Charlotte-Mecklenburg Planning Department

SUBJECT: Administrative Approval for Petition No. 2002-144 Euro Lodge, LLC

511 Queens Road
511 Queens Road
Charlotte, NC

ADMINISTRATIVE APPROVAL FOR PETITION 02-144

TECHNICAL DATA SHEET

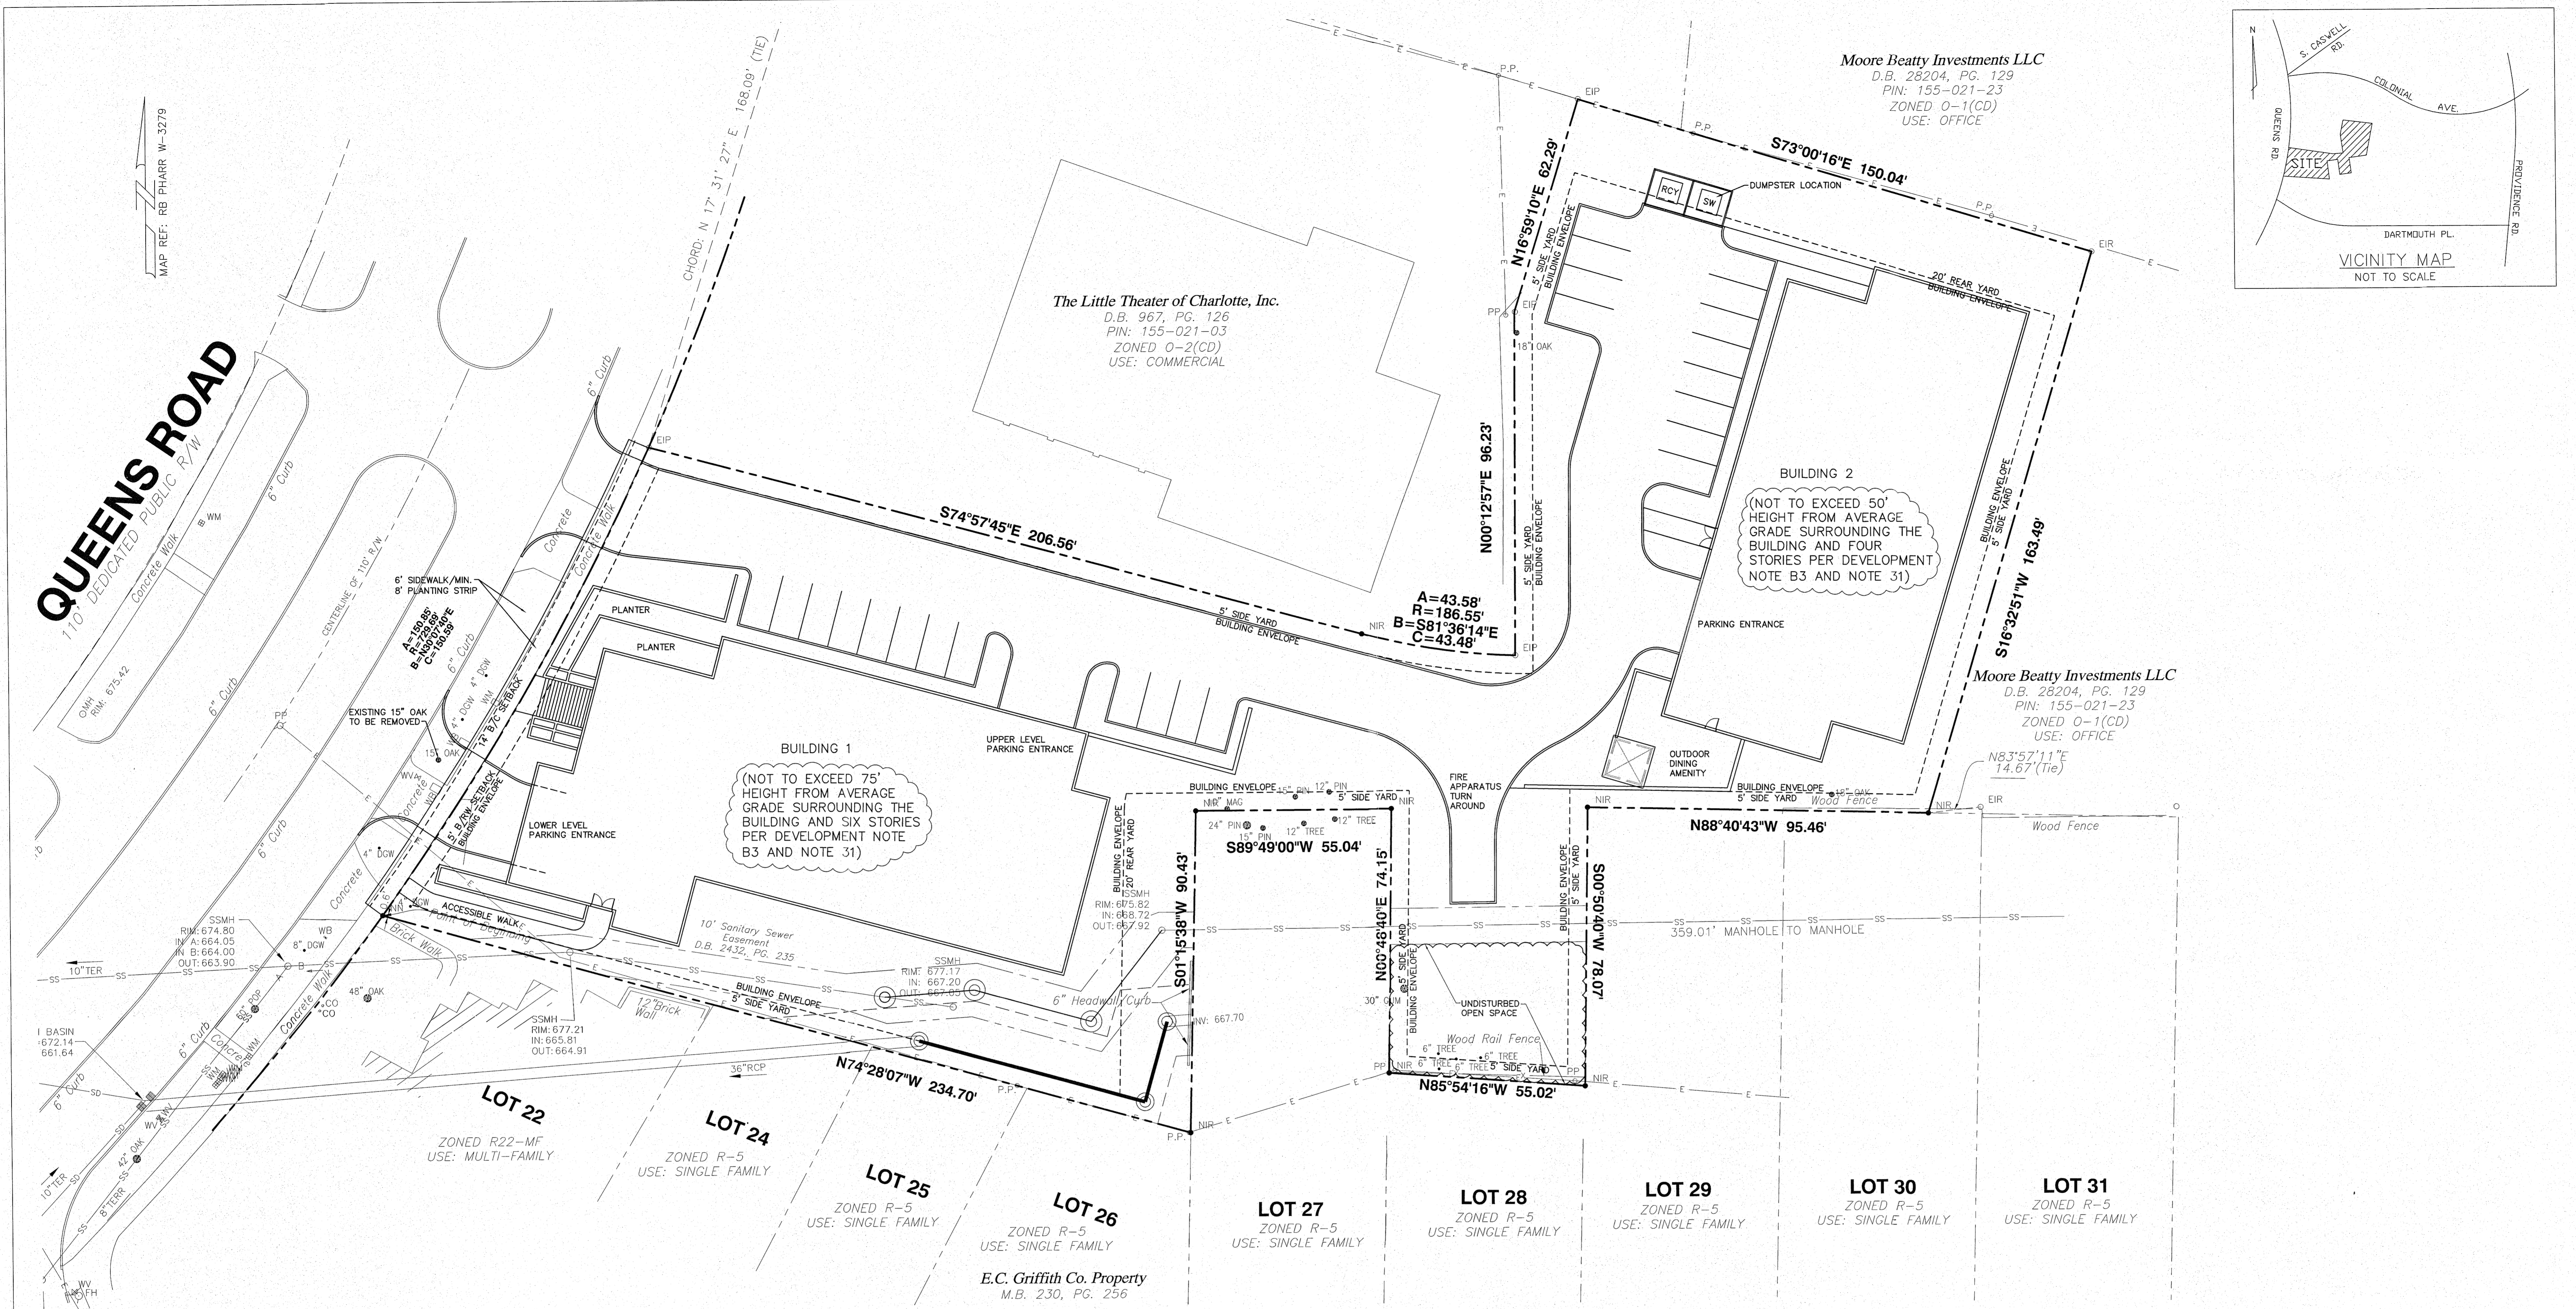
DEVELOPMENT CONDITIONS (NOTES WITH CLOUDS ARE REVISED FOR ADMINISTRATIVE APPROVAL)

SITE DATA:
TAX MAP NO: 155-021-04
EXISTING ZONING: UR-3(CD)
SITE AREA: 1.426 ACRES
PROPOSED USE: 62 RESIDENTIAL UNITS = 64 RESIDENTIAL UNITS

ATTACHED TO ADMINISTRATIVE
APPROVAL FRONT BUILDING
ELEVATIONS
AUG 5 2015

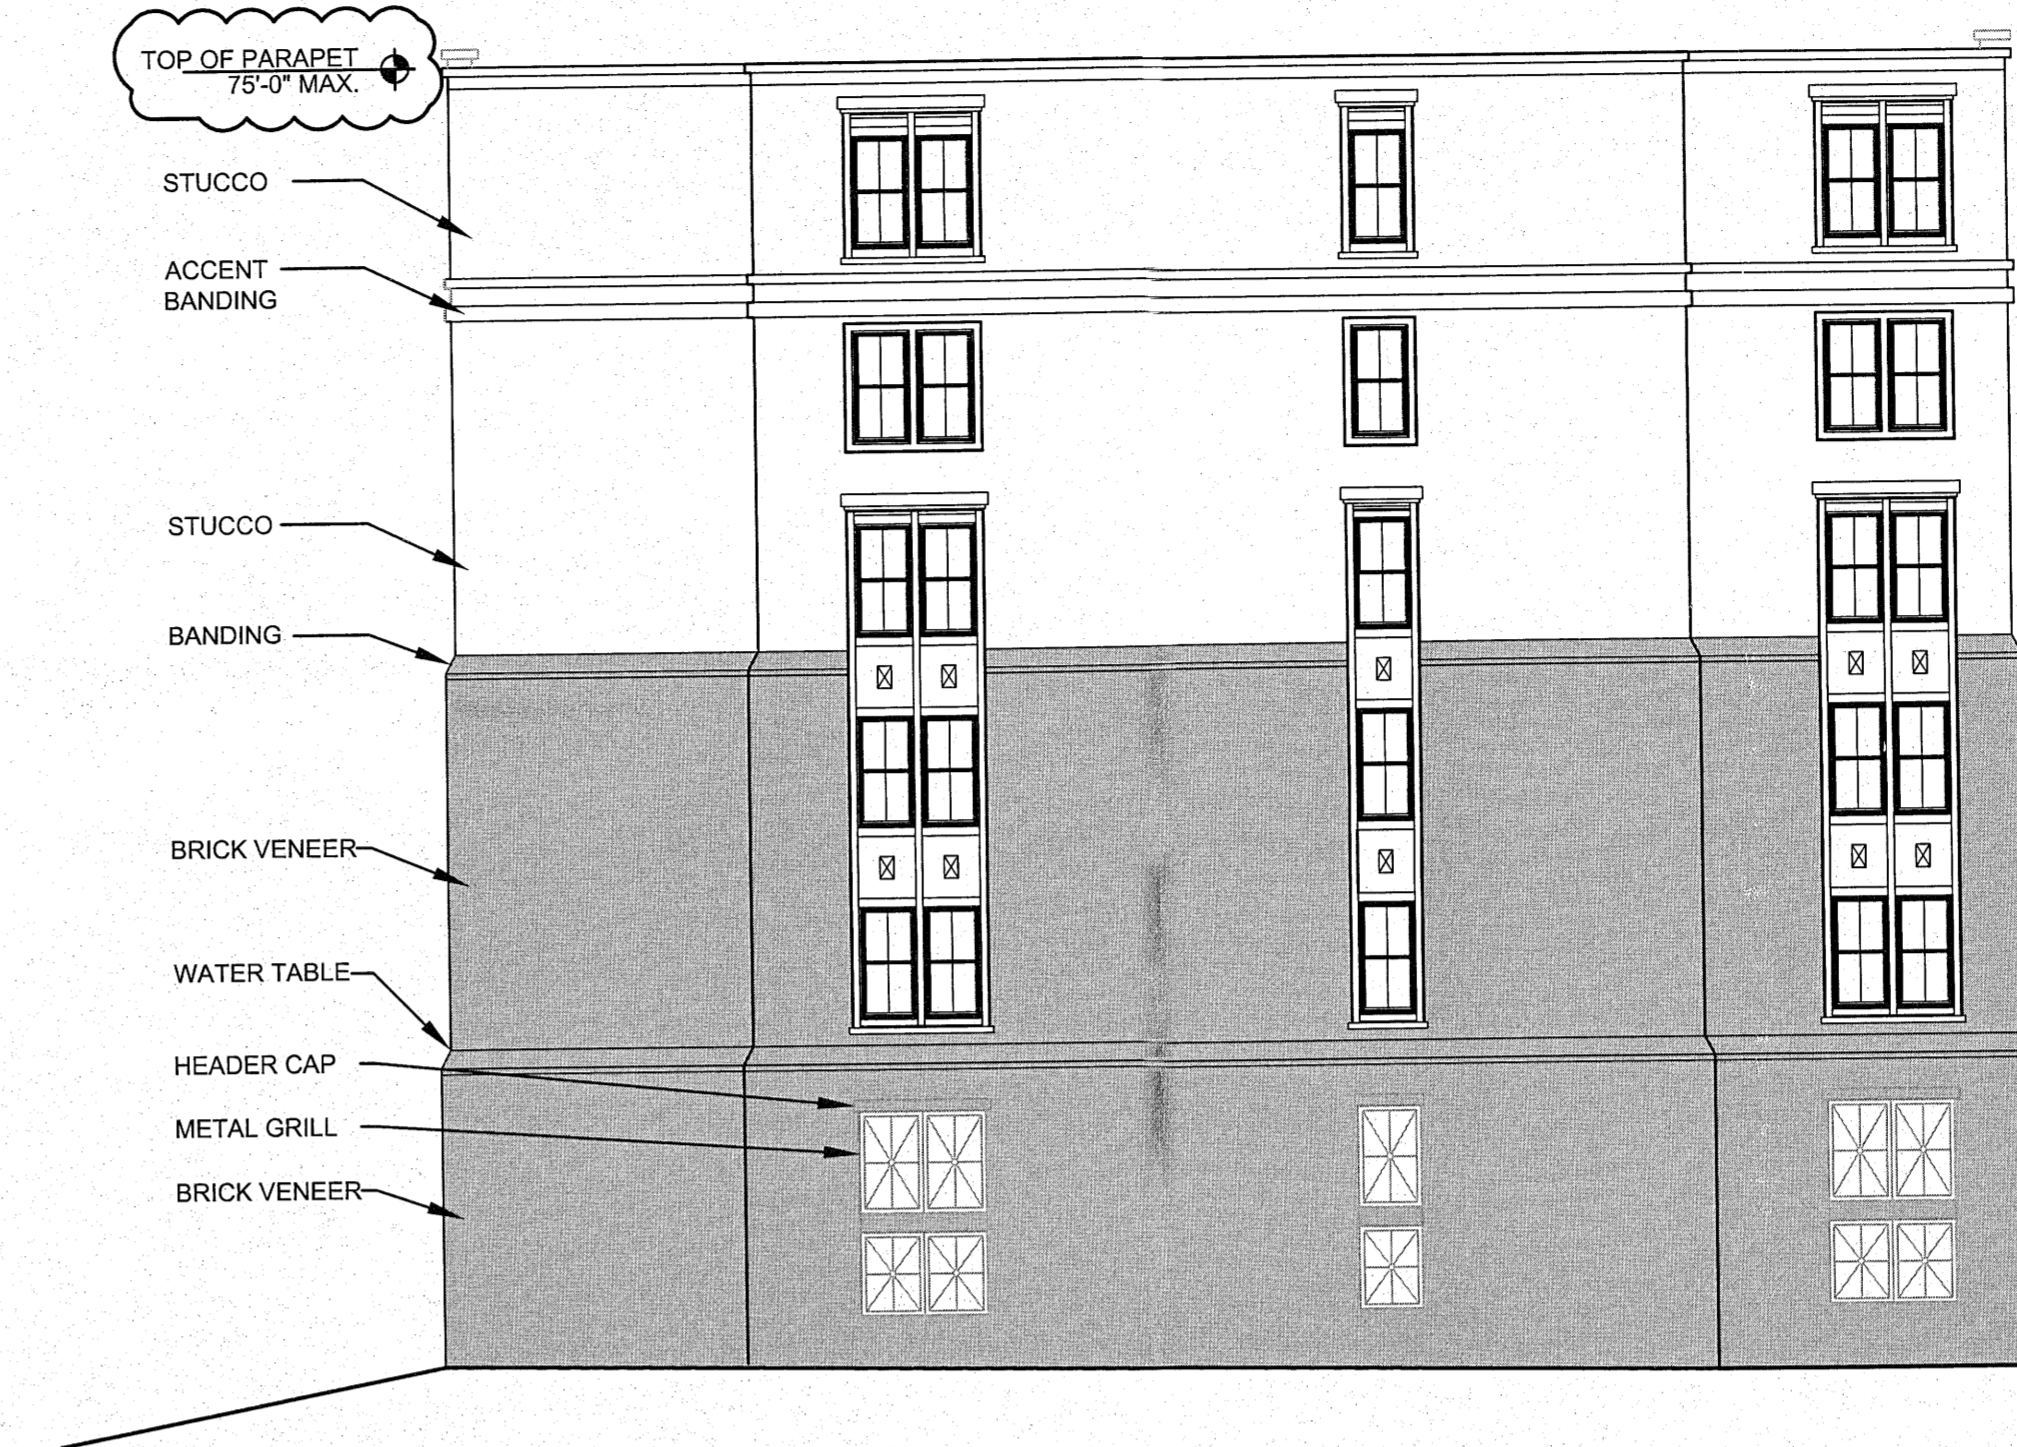
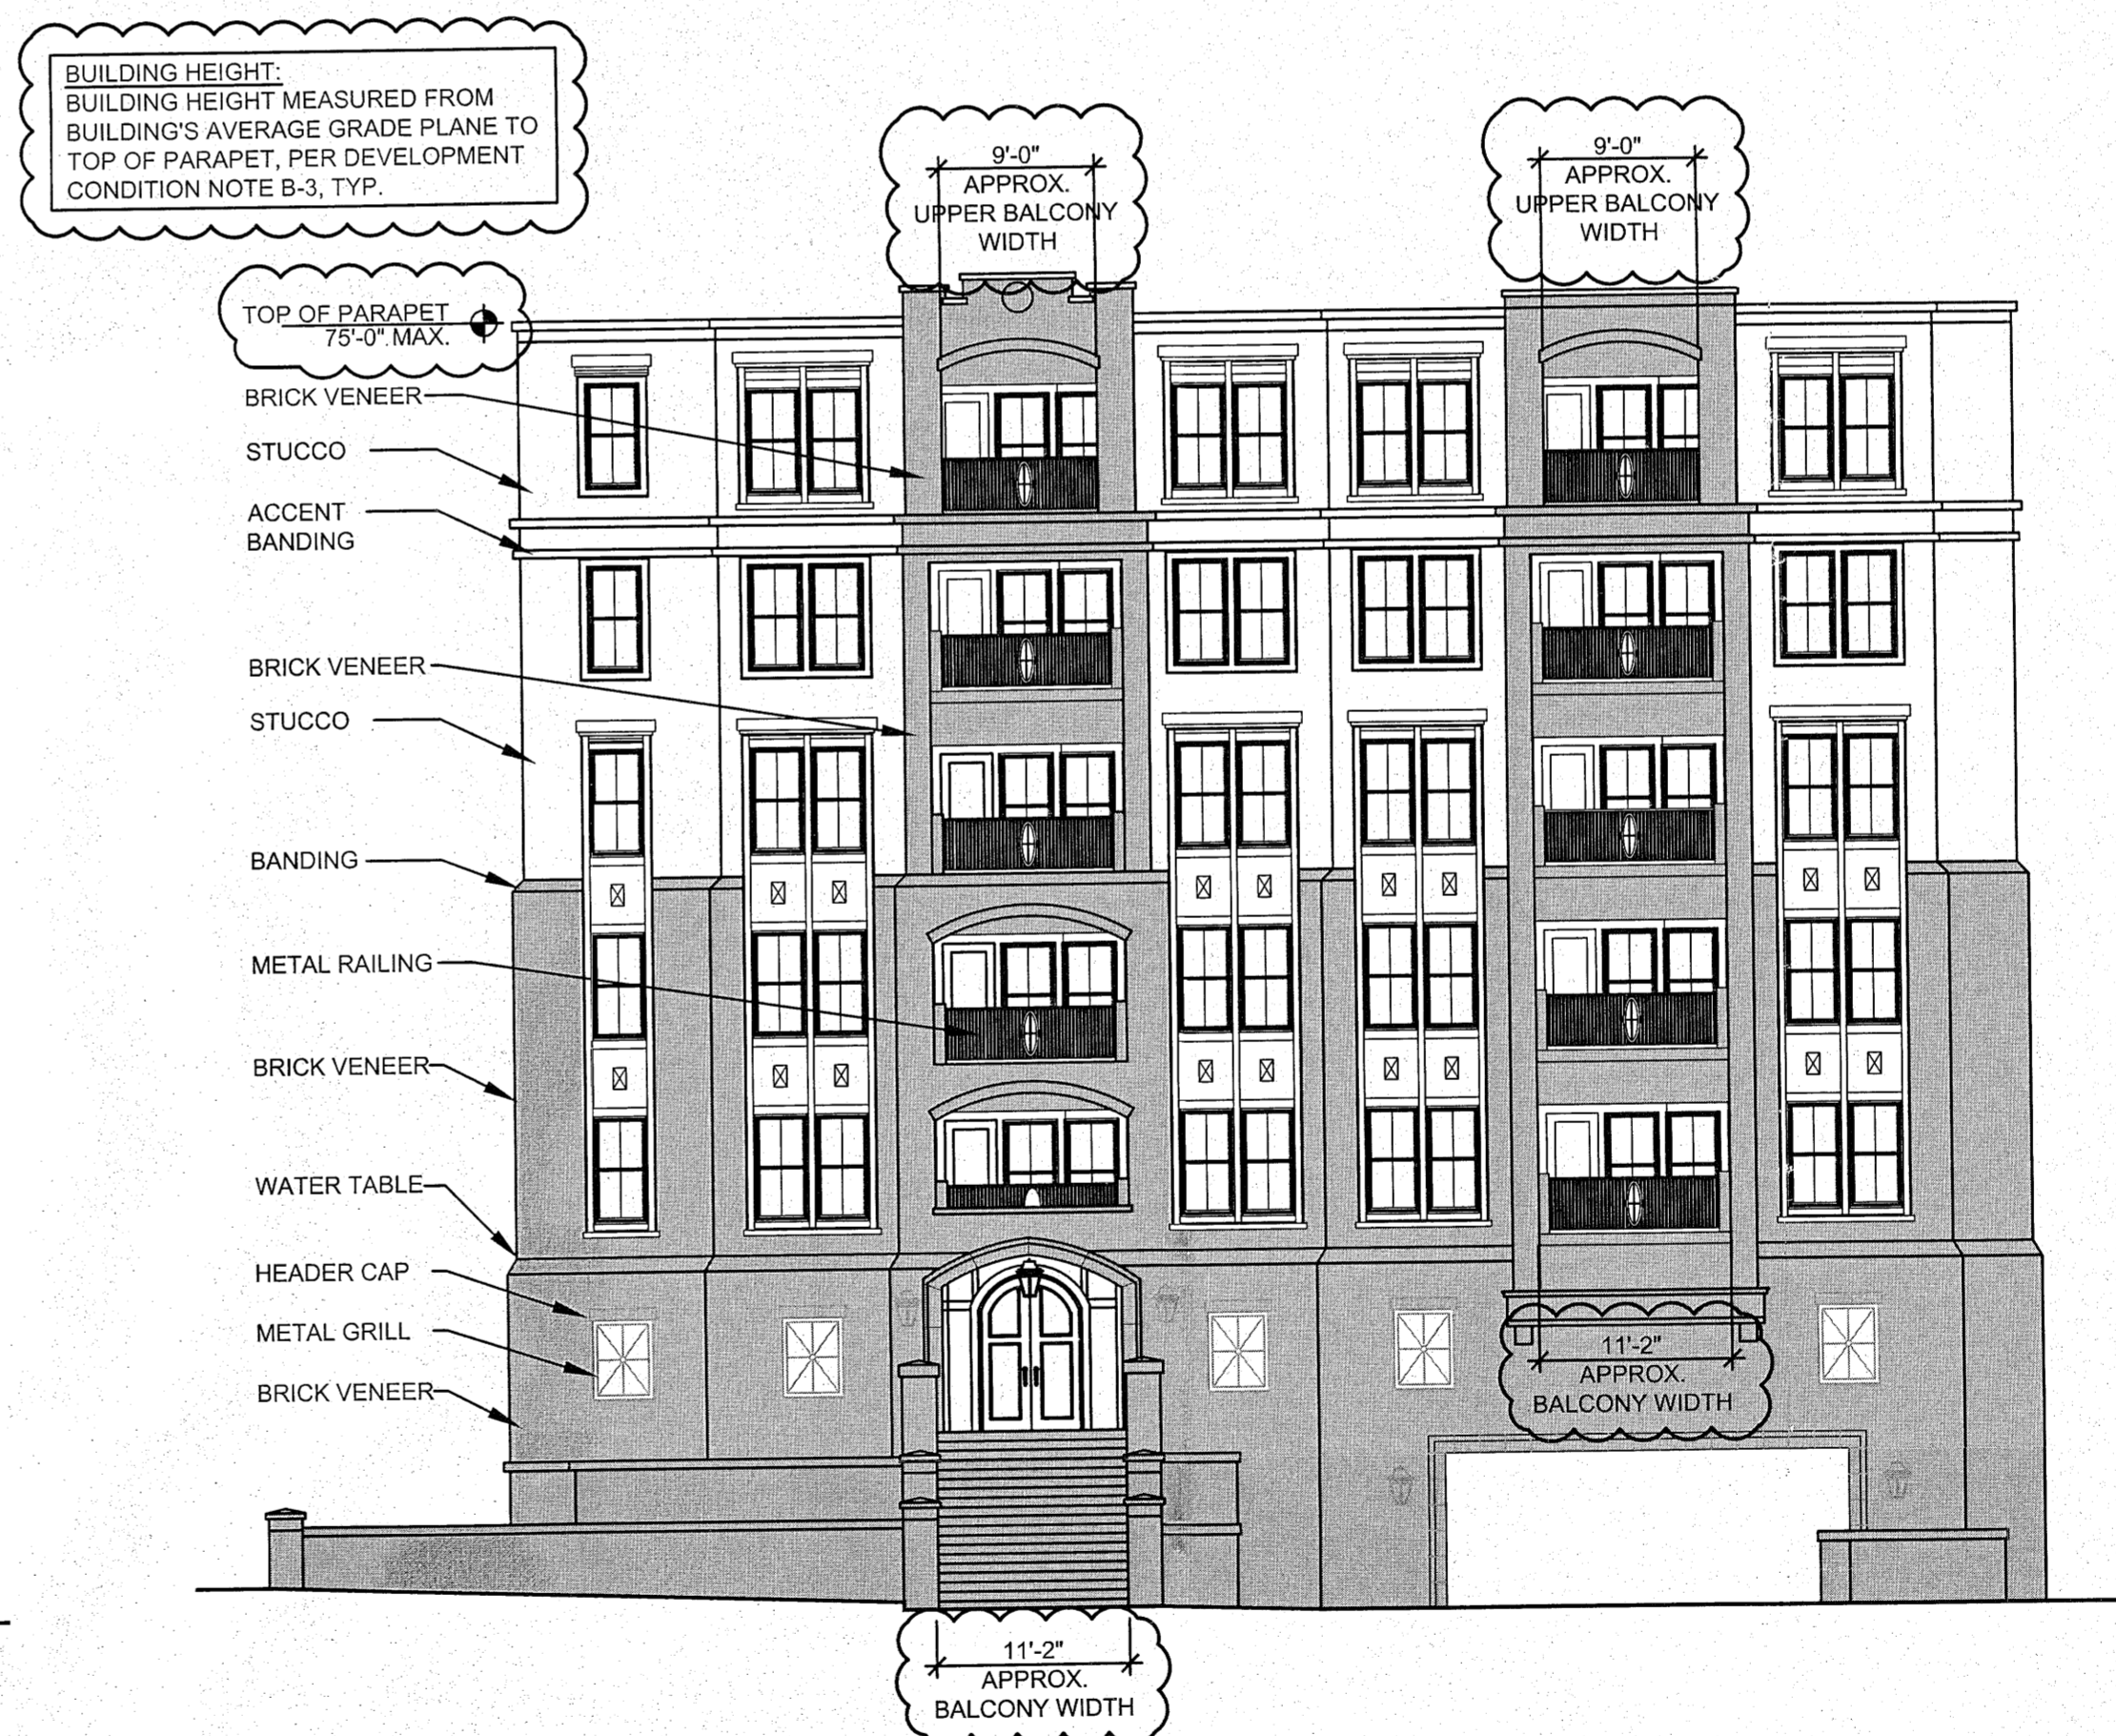
- Site Layout for the proposed residential use
- Building Elevations

FACADE MATERIAL PERCENTAGES							
Building 1 (Fronting Queens Blvd.)							
Hatch	Elevation (SF)				Total SF	% Provided	% Required*
	North	East	South	West			
Non-Brick/Masonry Veneer	3,468	2,721	3,419	1,720	11,328	43%	N/A
Brick/Masonry Veneer	4,341	2,925	4,667	2,918	14,851	57%	Min. 50%
Facade Total	7,809	5,646	8,086	4,638	26,179	100%
